## DRESDEN 2 &amp; 3

## IMPACT EFFECTS ON SPENT FUEL POOL SLAB

ATTACHMENT 2

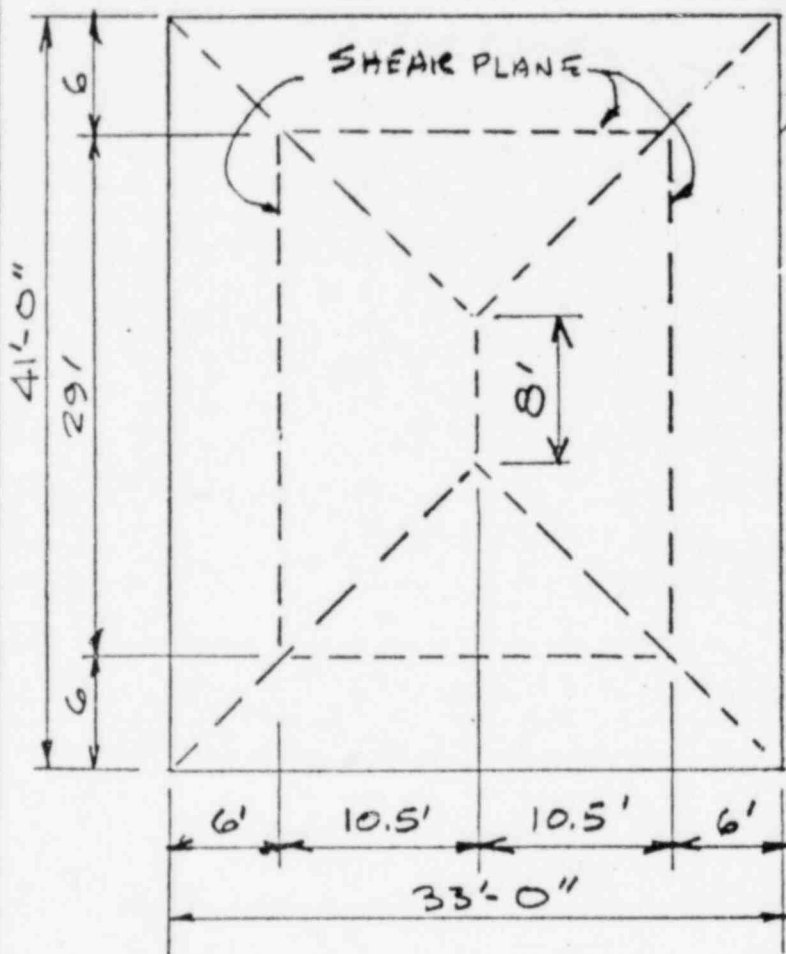
LOADING	KSF
D+H+L+E'	6.16 (Ref. 6)
RACK IMPACT	.76
TOTAL	6.92

$$V_{\text{TOT}} = 6.92(194.2) = 1344.2 \text{ K}$$

$$V_u = \frac{1344.2}{(29)(12)} = 3.86 \text{ K/IN}$$

$$V_c = 2\phi\sqrt{f'_c}d = 6.42 > 3.86 \quad \text{OK}$$

$$M_u = \frac{q_0}{\pi^2\left(\frac{1}{a^2} + \frac{1}{b^2}\right)^2} \left(\frac{1}{a^2} + \frac{1}{b^2}\right) = 265.6 \text{ FT-K/FT}$$

$$M \approx 20,000 \text{ FT-K/FT} > 265.6 \text{ FT-K/FT} \quad \text{OK}$$
